Access Compliance Report

Public Rights-of-Way

(Curb Ramps)

Intersection ID: 30292	Main Street: DERRYFIELD_DR	Cross Street: NIGEL_CT	Location: S
ADA ID: 1D74BB2755BF	Ramp Type: BlendTrans1	Initial Pass/Fail: Pass	Overall Compliance: No
Codes/Mitigation Info/Possible Solution			Severity Score: 10
			Field Measurements/Component Compliance

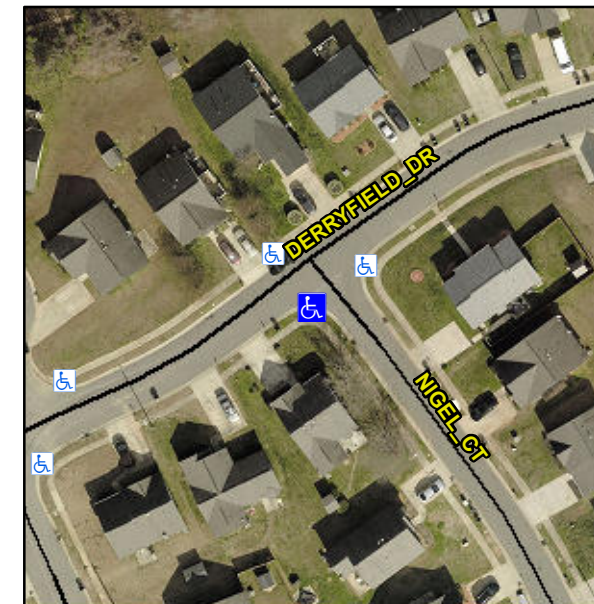
Remove & Replace Curb Ramp With Two New Directional Ramps or Equivalent.

CURB WIDTH 44.5

Not Found, R304.2.2-Perp, R304.3.2-Para, R305.1.4, R305.2, R302.7.2
